**PARAMETERS & REGULATORY TEXT
UPDATE DOCUMENT**

SKIMMINGDISH LANE, BICESTER

ALBION LAND

September 2015

Parameters Plan - Development Area & Building Zone

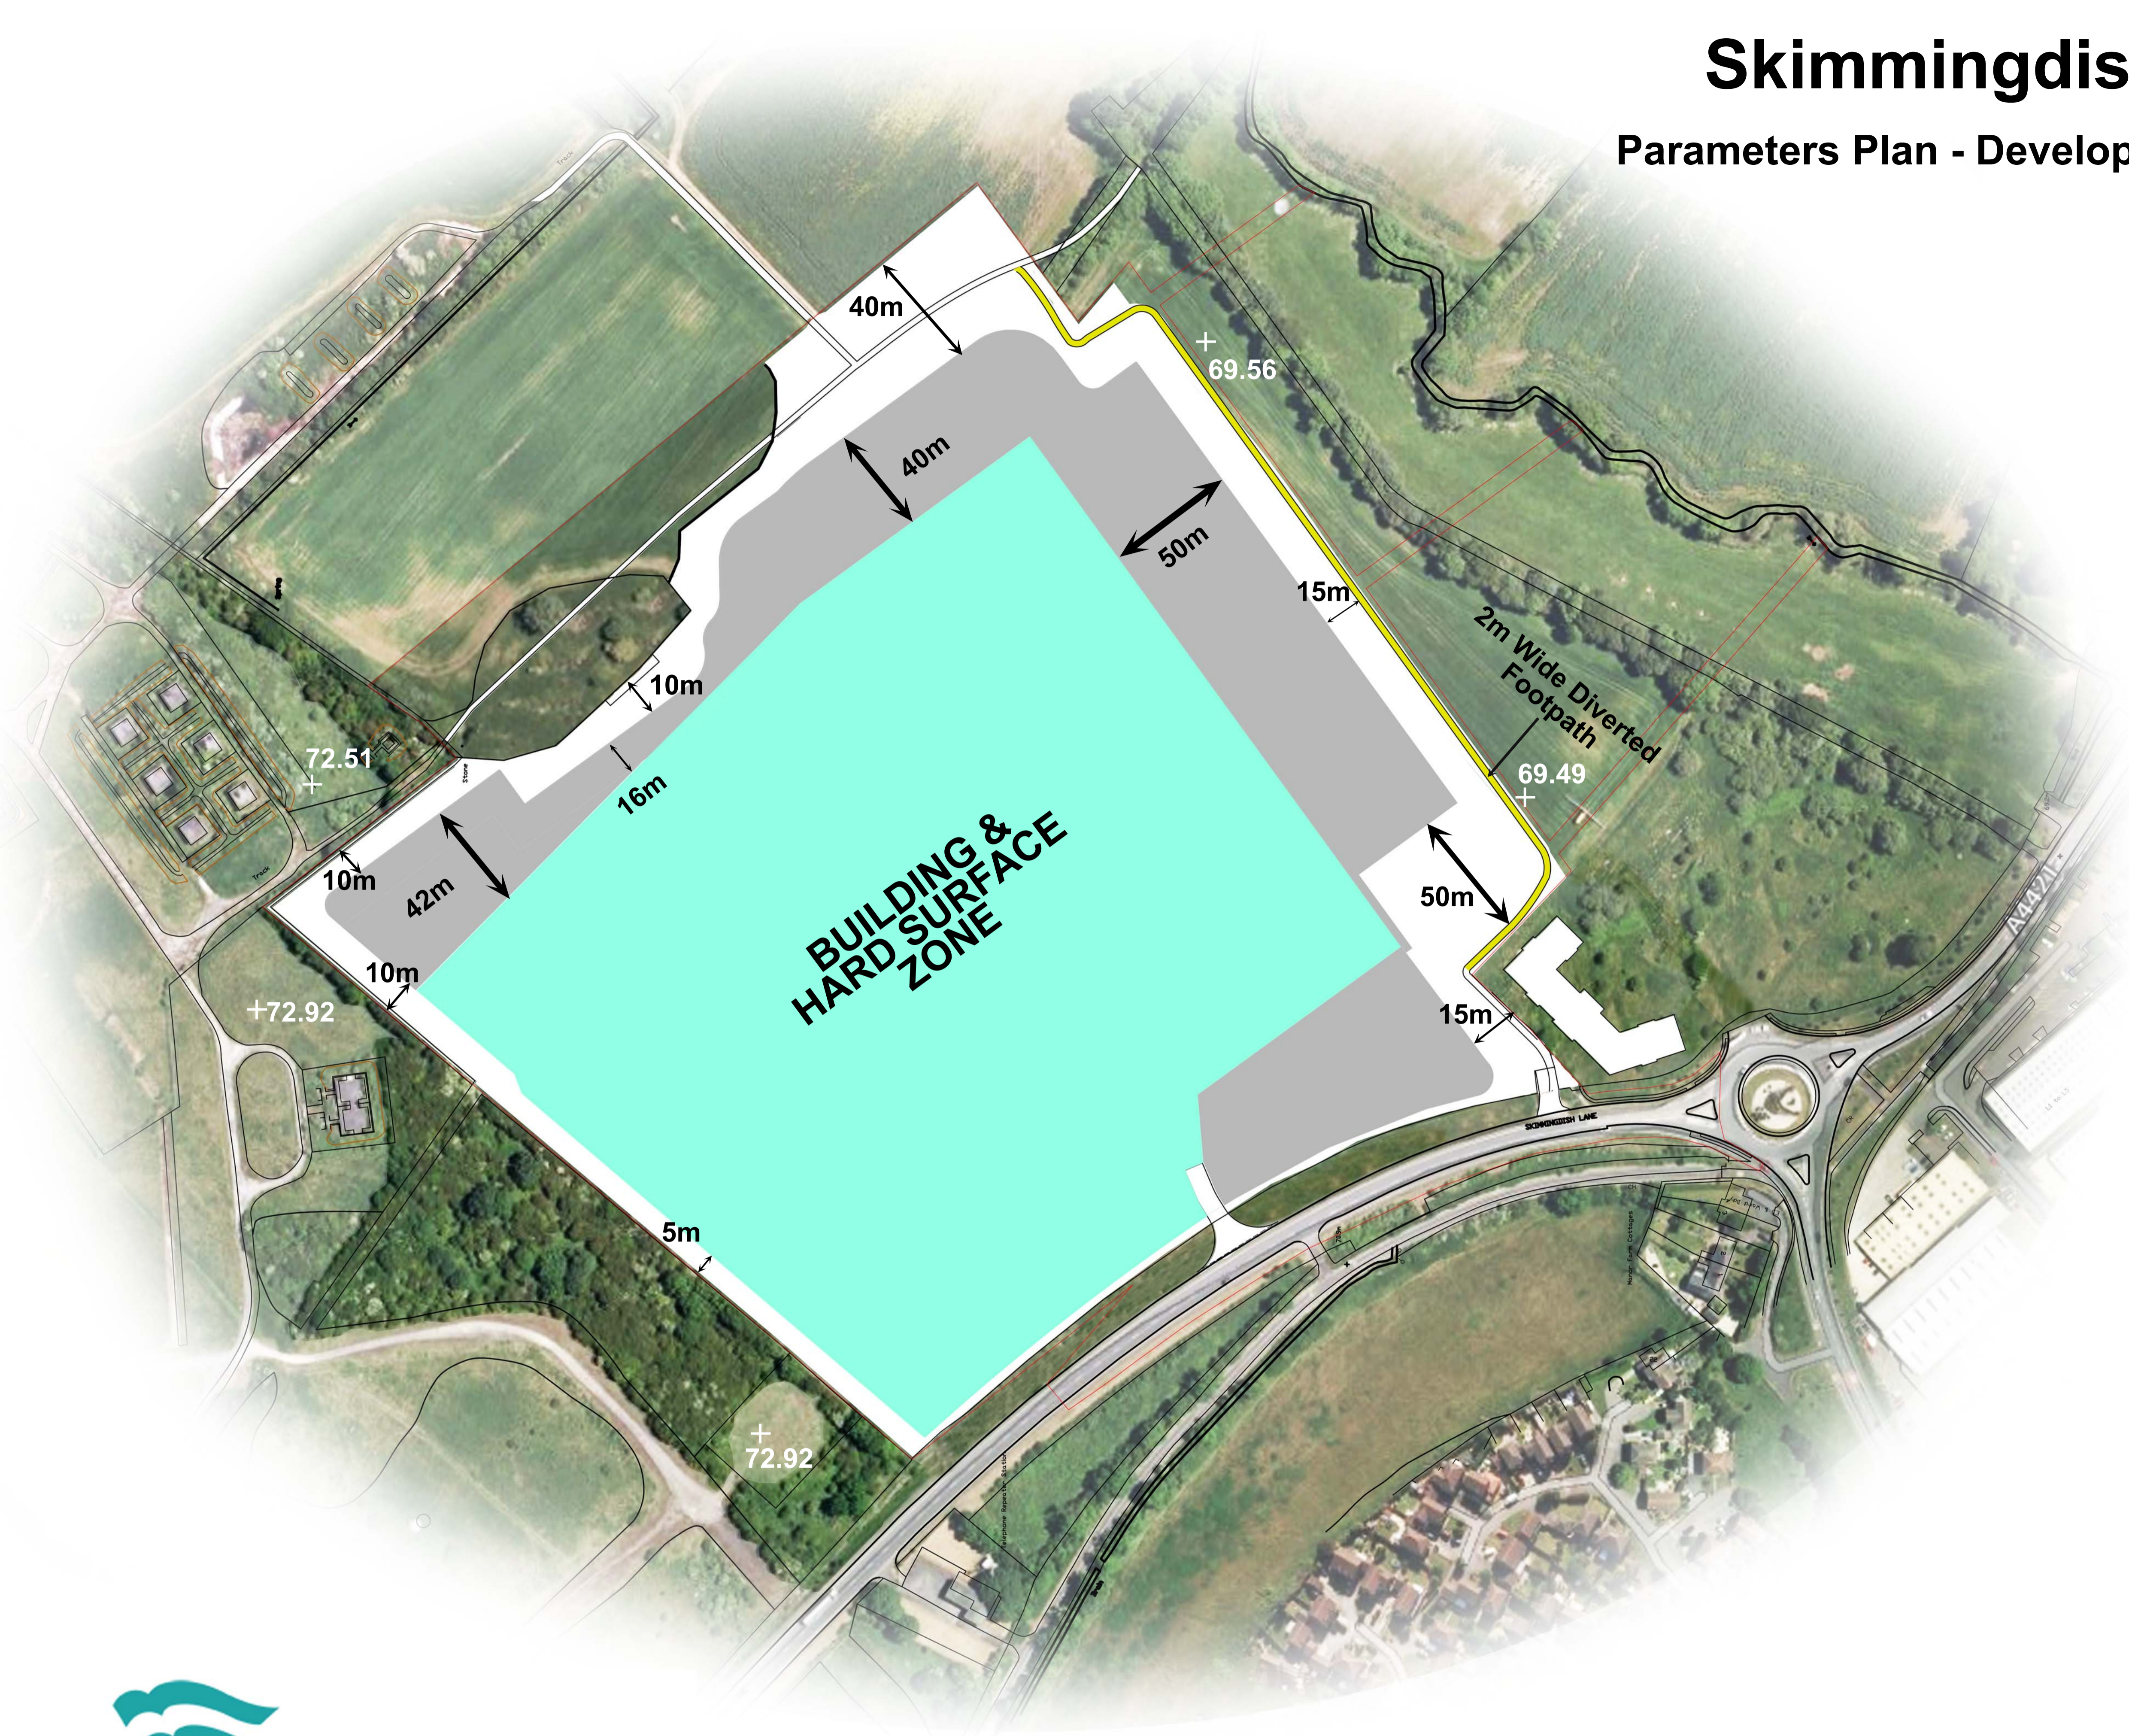
2.6 Parameters Plan reference 3830-25-21 (see **Appendix 1**) sets out the following details:

- The parameter plan differentiates this area from that on which buildings can be located (shown in dark blue). This area has been amended as part of the recent scheme changes to ensure that no buildings are located outwith the adopted Bicester 11 allocation area. This has reduced the building area zone from that originally submitted;

- Approval is also sought for the siting of the building to the south of this site. This element has again altered from the original submission which provided for two buildings in this location;

- Given the need to draw back the building zone from the areas at risk of flooding, these buildings have been combined to form a single employment unit. The position of these buildings has also been tested through the application. The siting of this unit is shown on a separate Building Siting Plan ref 30-30-05 for which planning approval is sought;

Parameters Plan - Site Levels & Building Heights

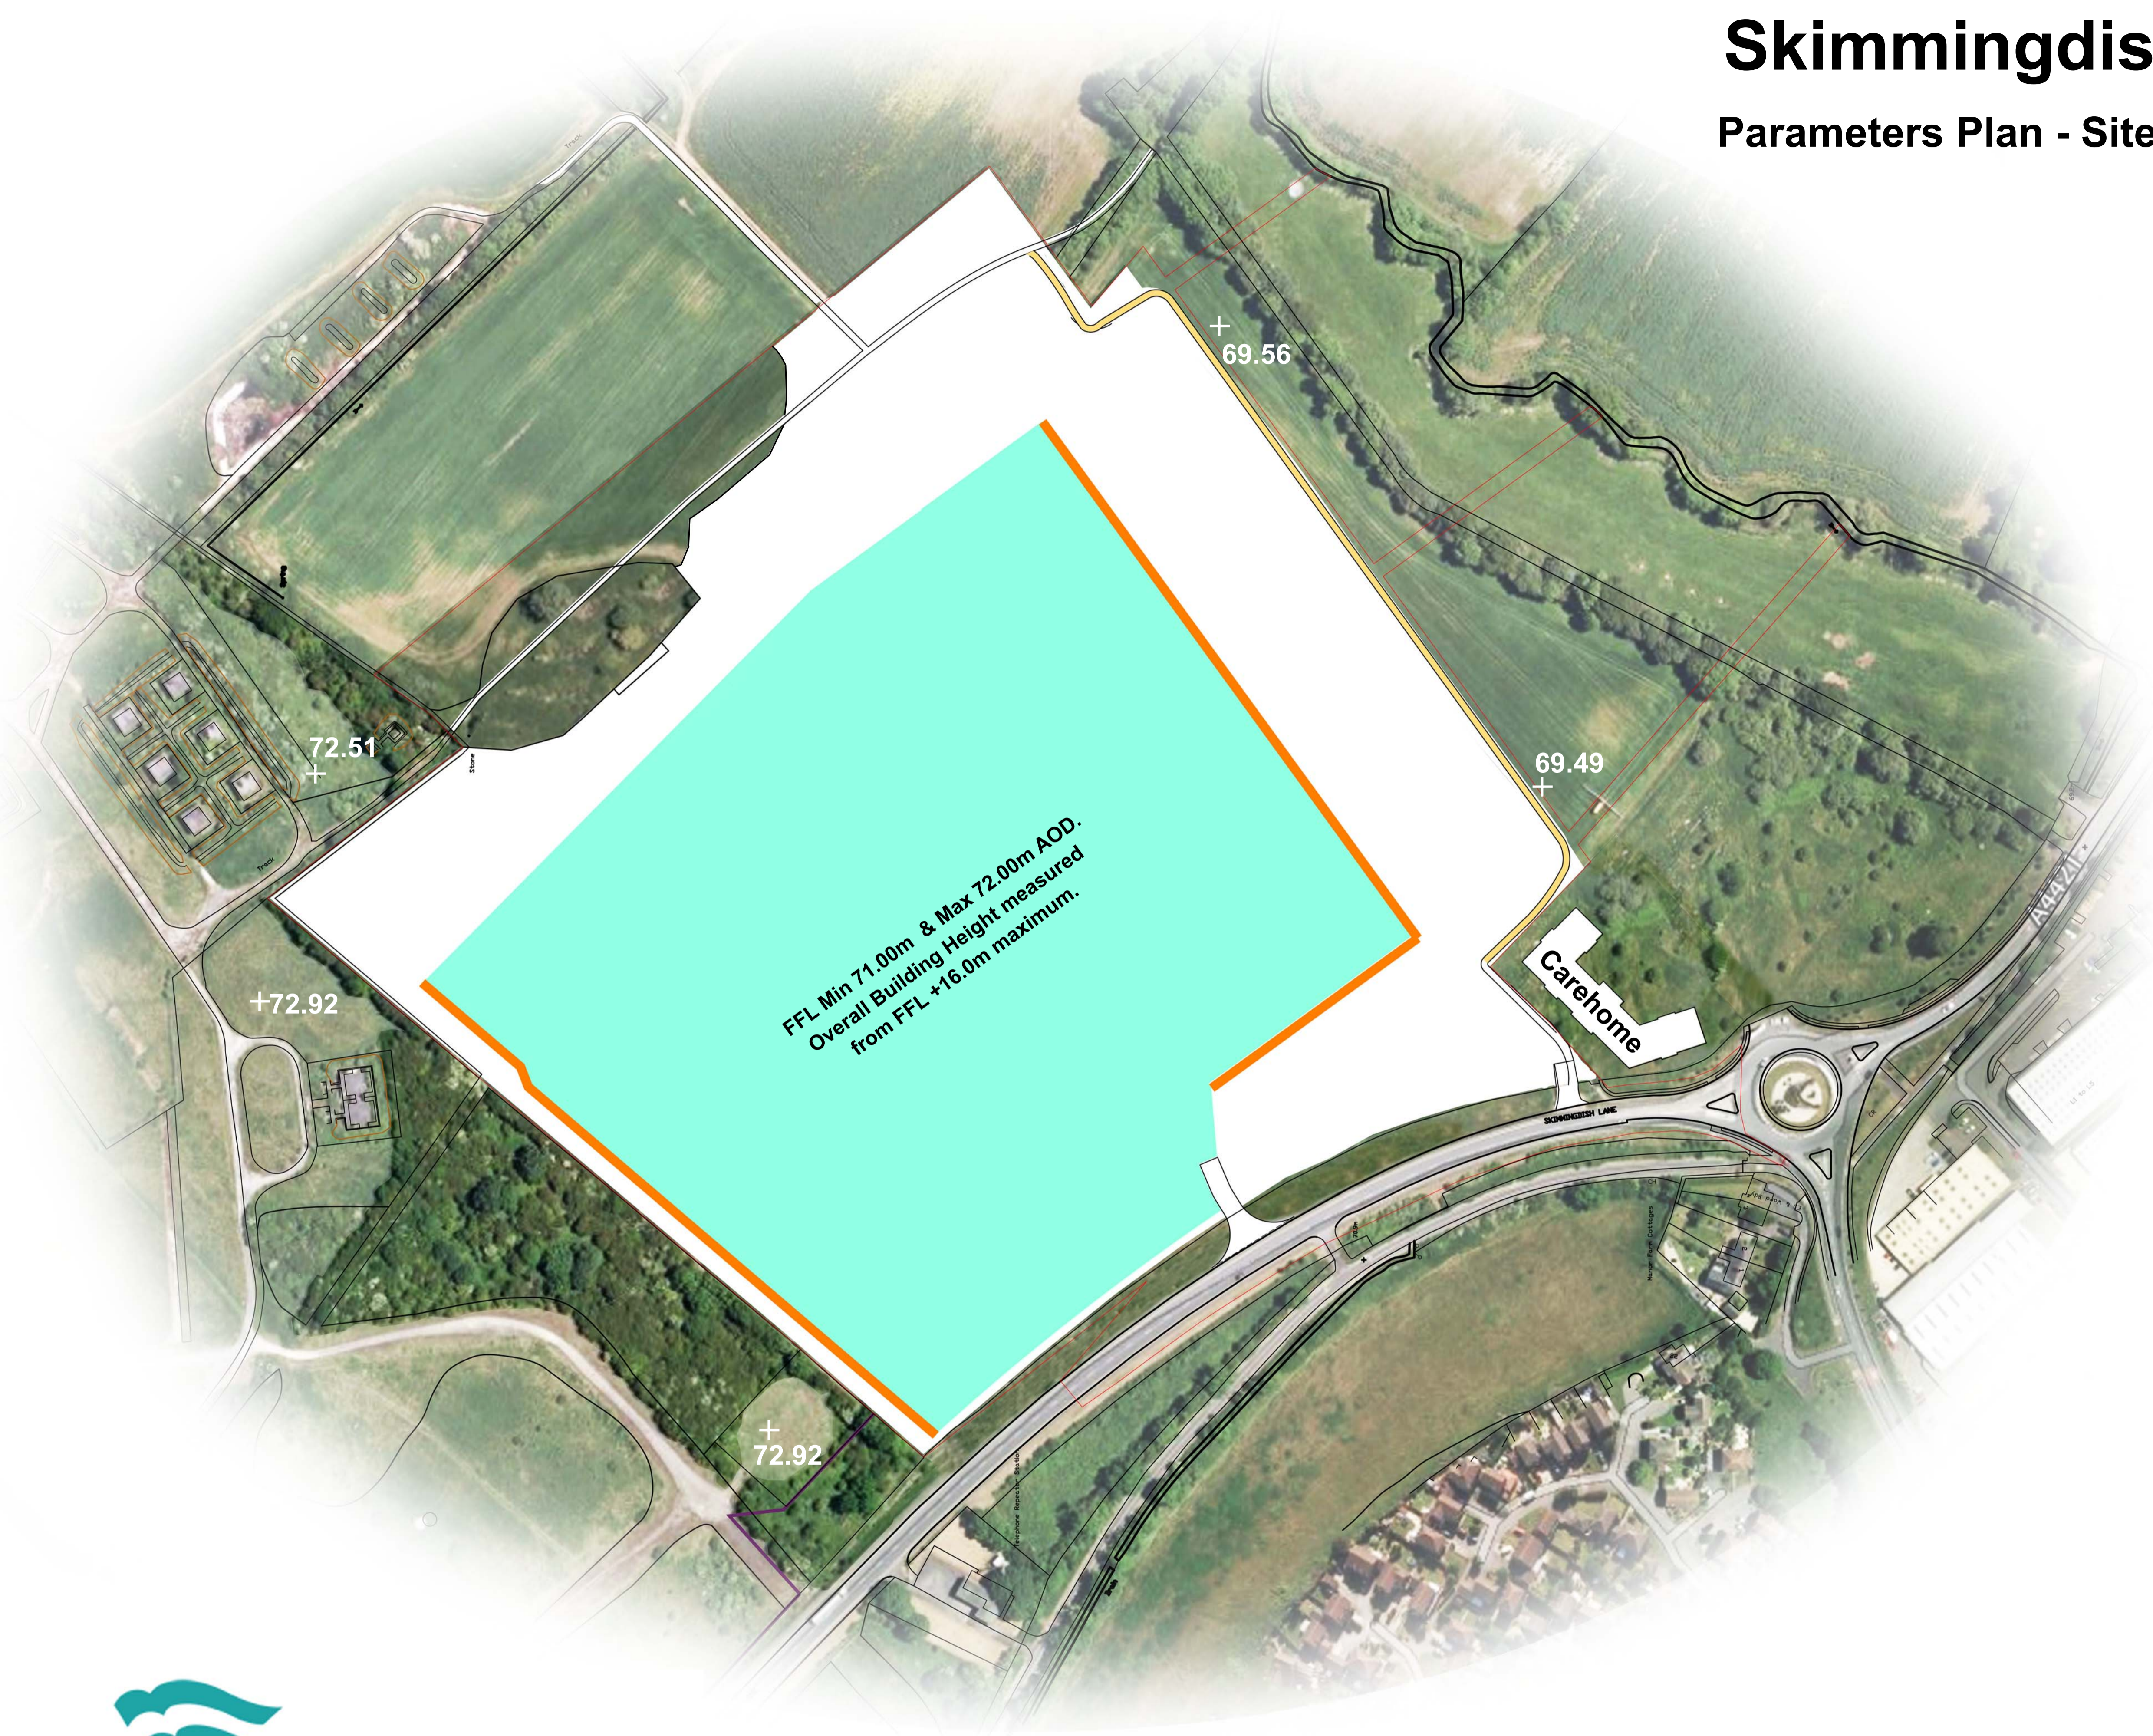
2.7 Parameters Plan Ref 3830-29-08 (see **Appendix 2**) includes the following details:

- Maximum and minimum finished floor levels (FFL) (expressed in metres AOD) are fixed across the site. As per the original submission, the maximum floor level is fixed at 72 m AOD and the minimum set at 71 m AOD;

- The maximum building height (across those areas in which buildings will be permitted) is set at 16 m floor to pitch. The maximum height of any building on site is, therefore, set at 18 m AOD.
- In response to consultation comments received from the Landscape and Conservation Officers (see Planning Report Addendum), the maximum building height of the building's façade on the southern, outer western edge and the northern edge of the building zone has been set at 14.5 m above FFL.
